HILLPOINTE APARTMENTS AT PETERSON SITE DEVELOPMENT PLAN

SITE DEVELOPMENT PLAN
COVER

PPR-26-13
PCD FILE NO.

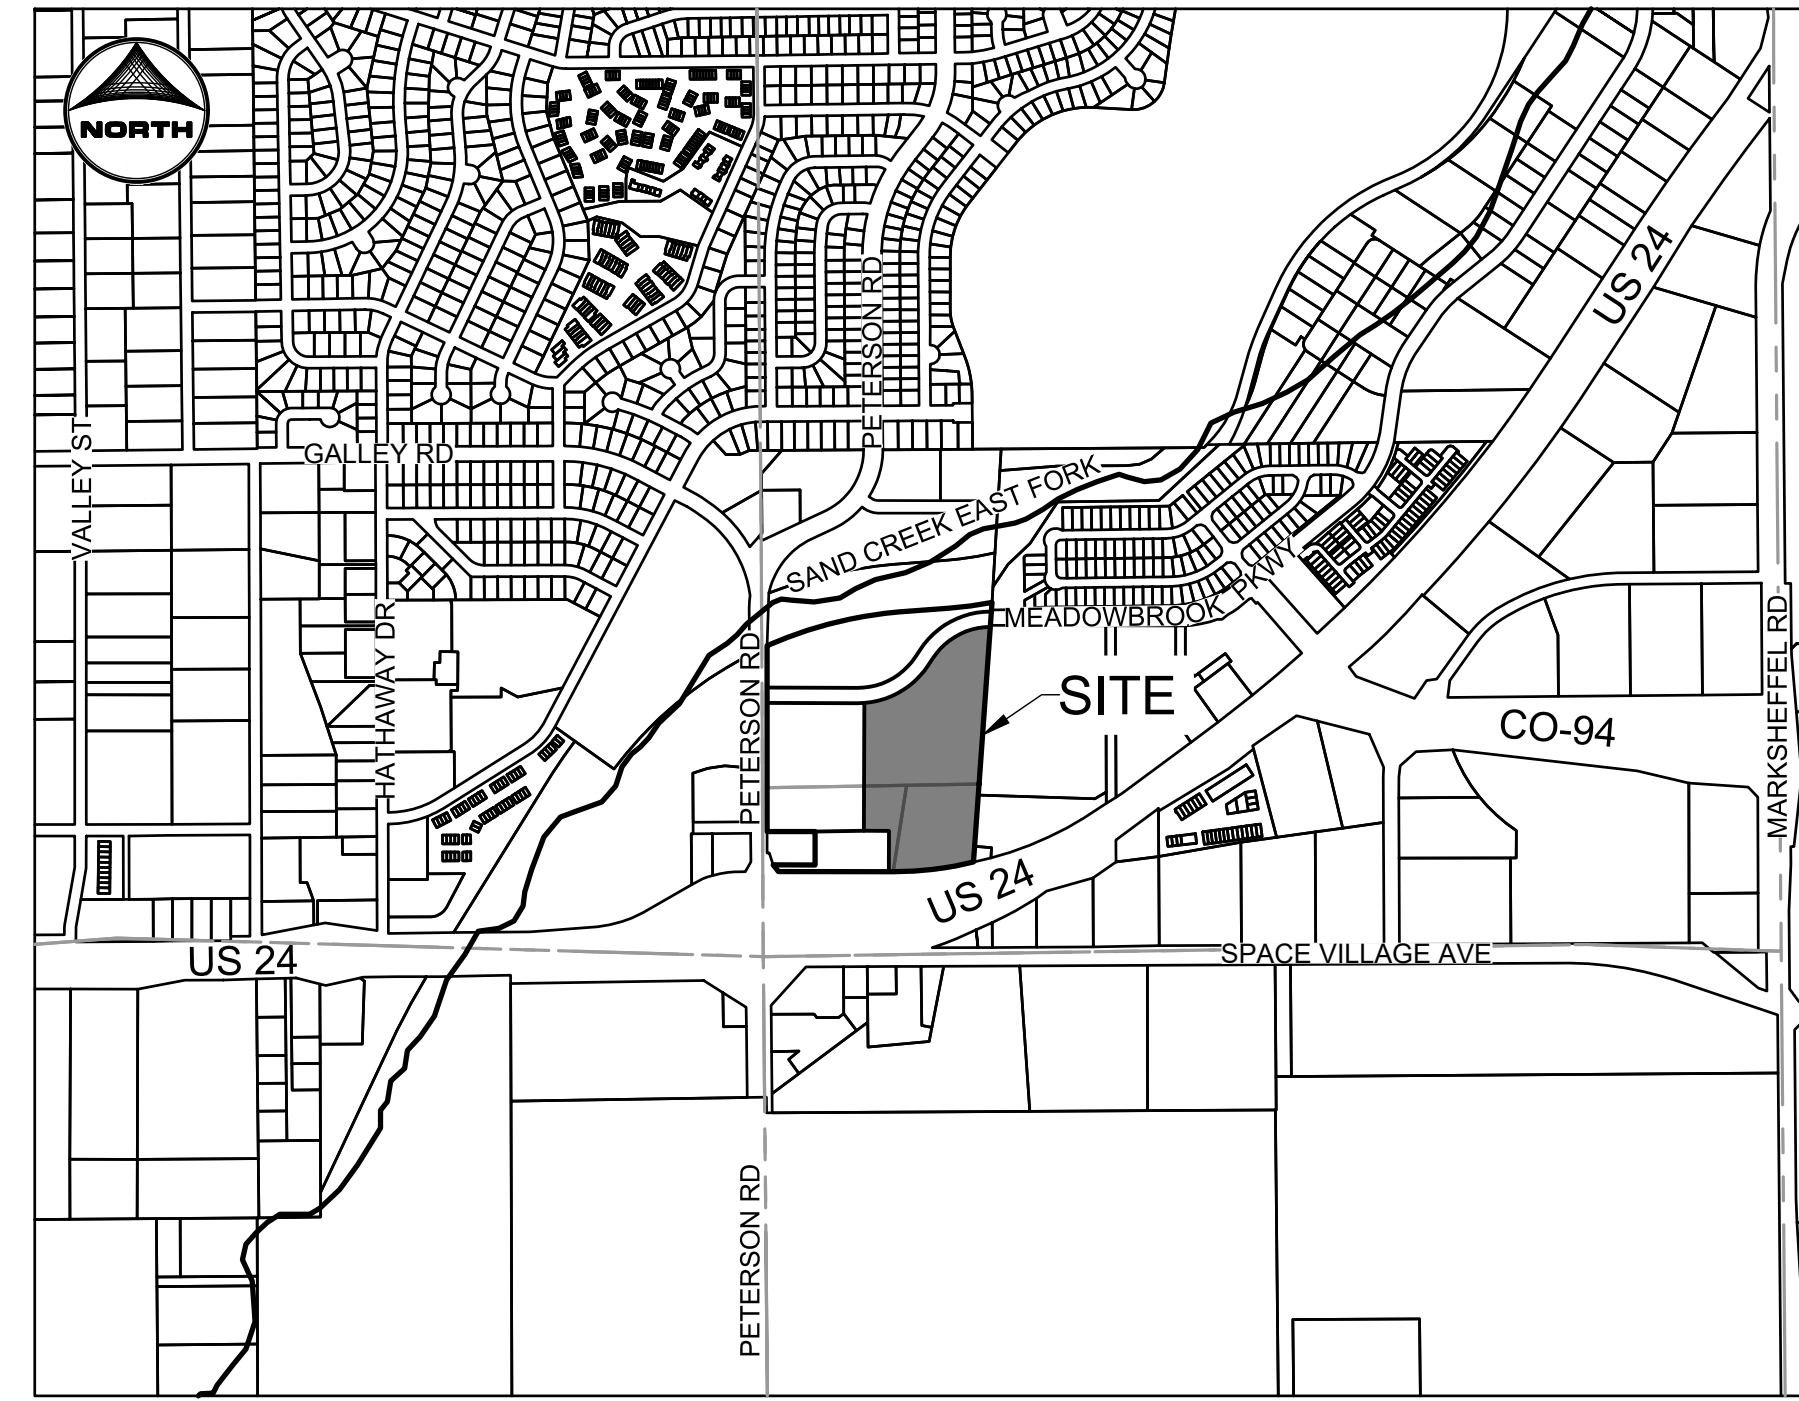
Please note that the Final Plat and Rezoning must be approved prior to final review and approval of this Site Development Plan.

Comments provided herein are preliminary, and subject to change dependent on the Plat and Rezoning status / conditions.

Comments are provided under the assumed future Final Plat and Rezoning conditions.

Please provide current legal description of parcel, not what it will be after plat.

Include Floodplain Statement, Geologic Hazard and ADA notes

HRG Response:
Acknowledged.

HRG Response:
Kept as this description as this will be what it is at approval of the SDP.

HRG Response:
Added.

SITE DEVELOPMENT PLAN
SITE PLAN

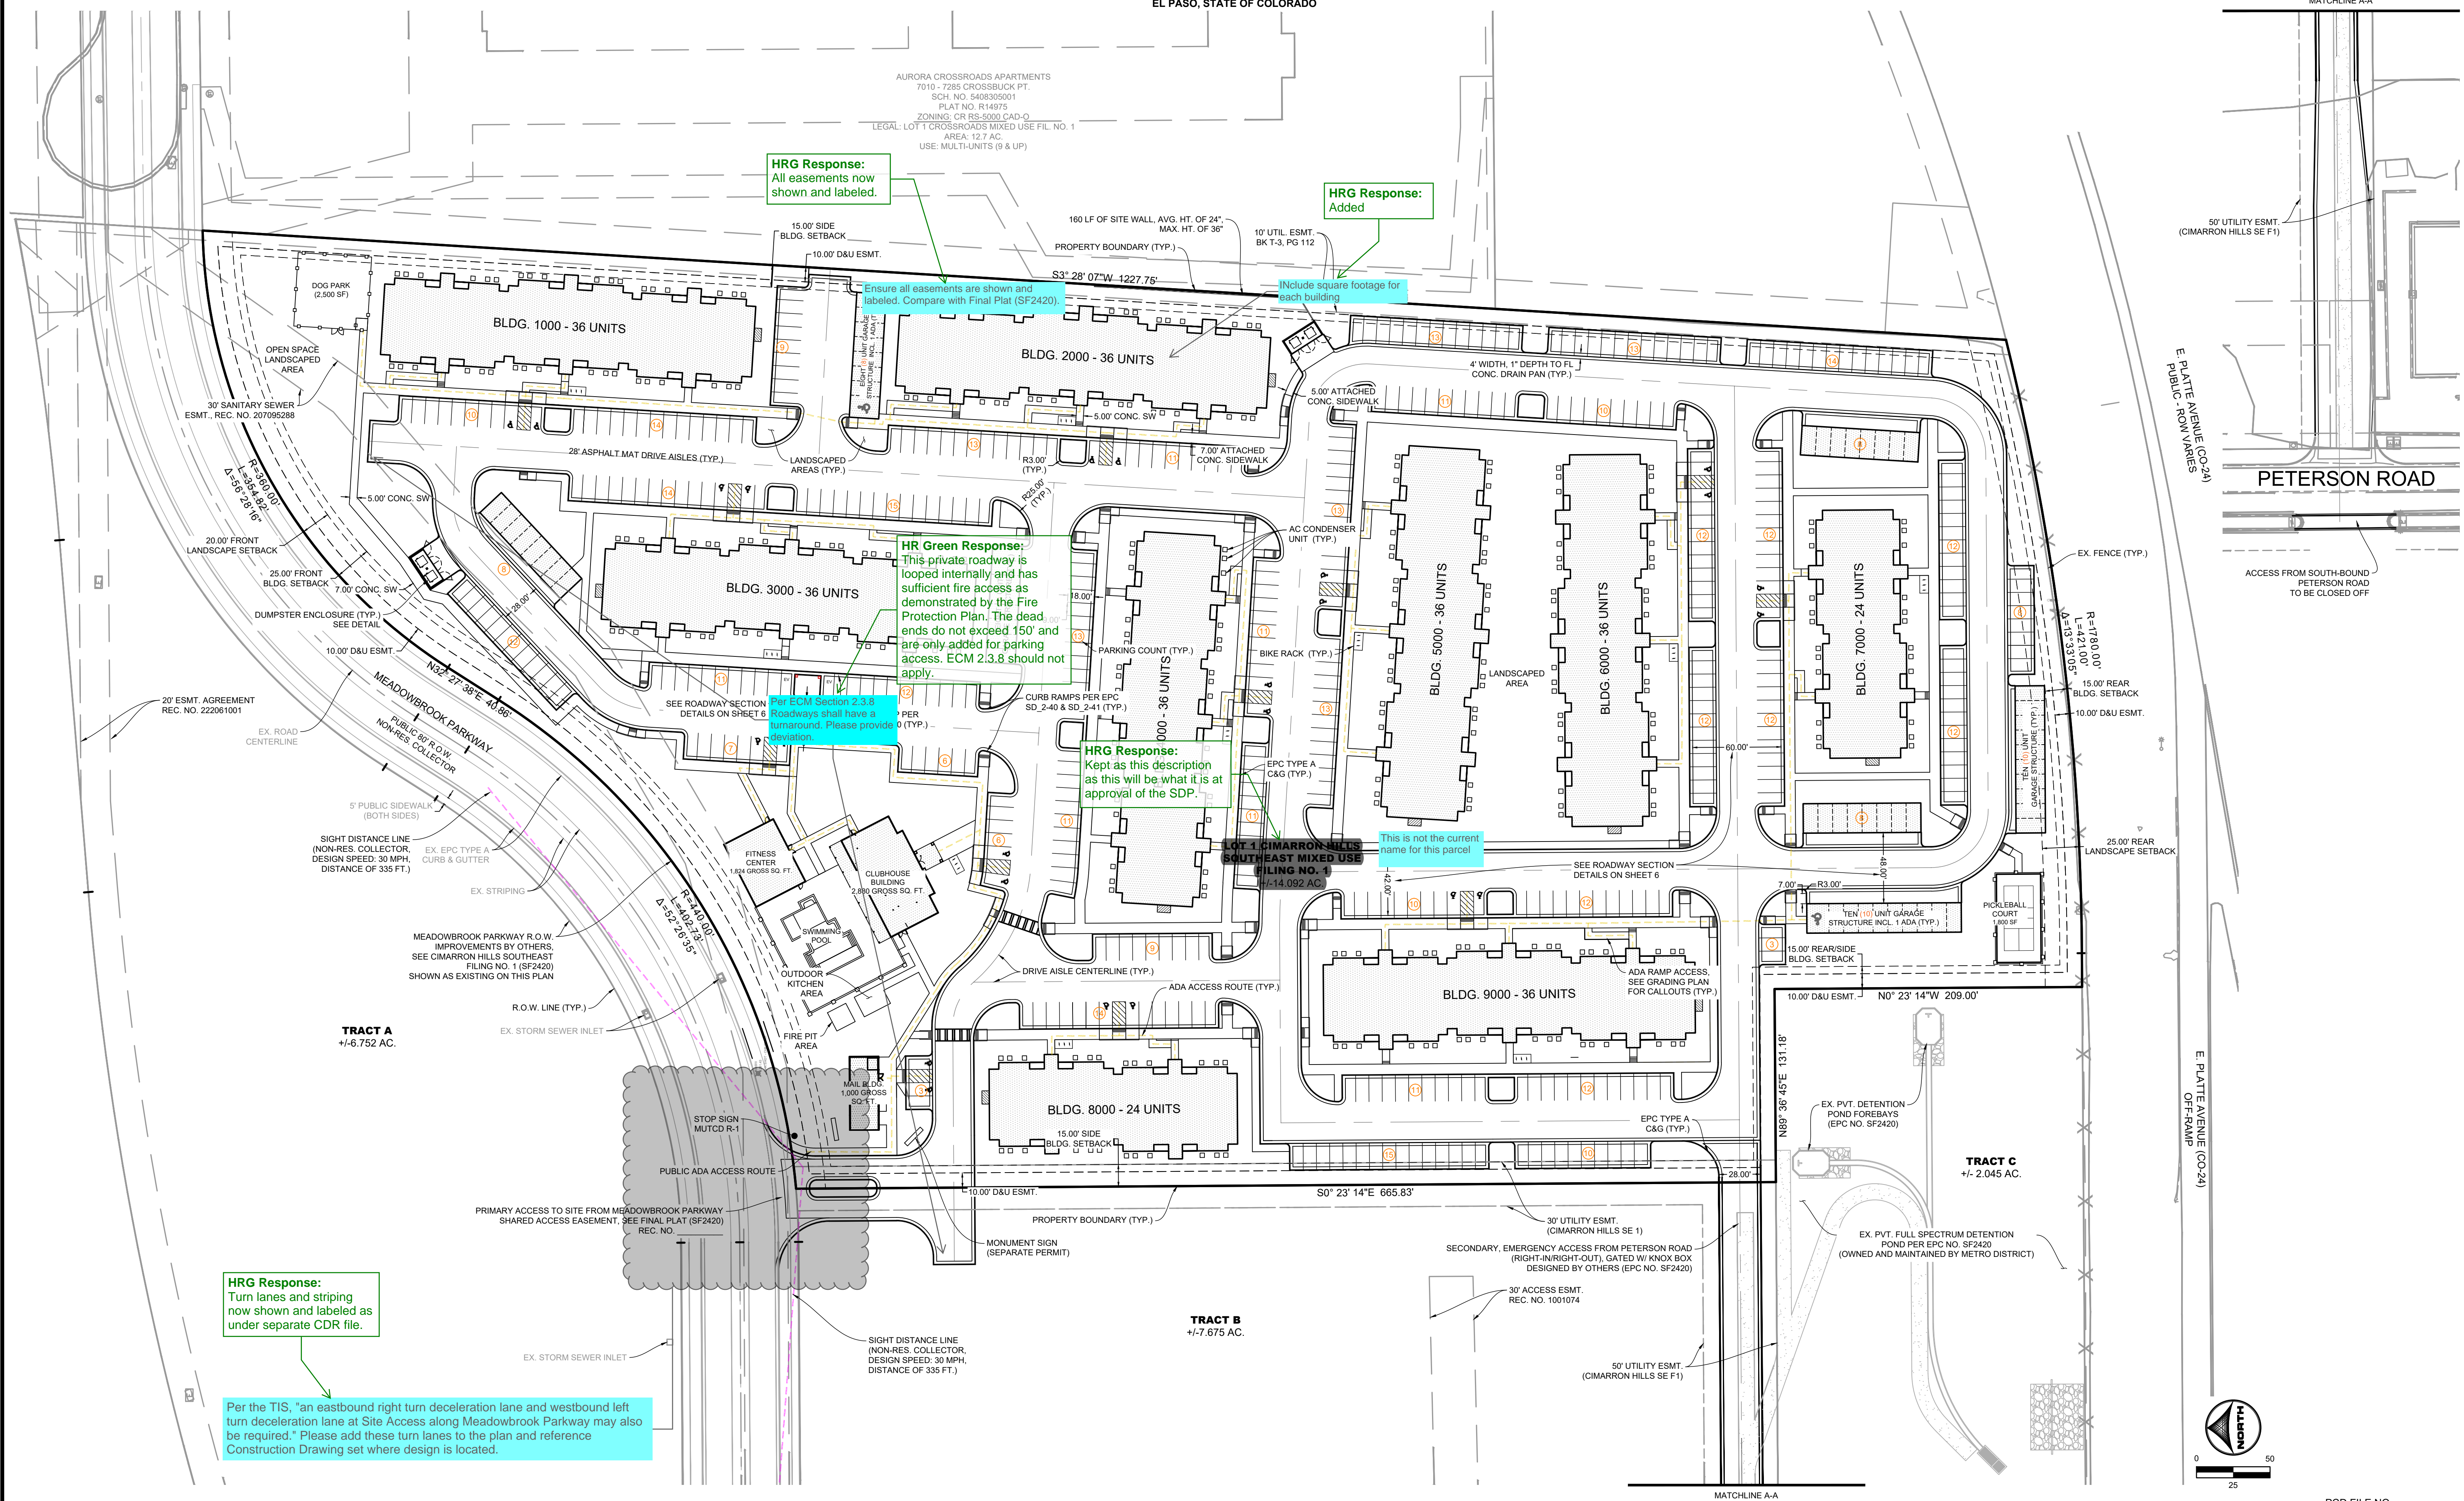
Per the TIS, "an eastbound right turn deceleration lane and westbound left turn deceleration lane at Site Access along Meadowbrook Parkway may also be required." Please add these turn lanes to the plan and reference Construction Drawing set where design is located.

Per ECM Section 2.3.8 Roadways shall have a turnaround. Please provide a turnaround.

This is not the current name for this parcel

HRG Response:
Turn lanes and striping now shown and labeled as under separate CDR file.

HRG Response:
All easements now shown and labeled.

HRG Response:
Added

HR Green Response:
This private roadway is looped internally and has sufficient fire access as demonstrated by the Fire Protection Plan. The dead ends do not exceed 150' and are only added for parking access. ECM 2.3.8 should not apply.

HRG Response:
Kept as this description as this will be what it is at approval of the SDP.
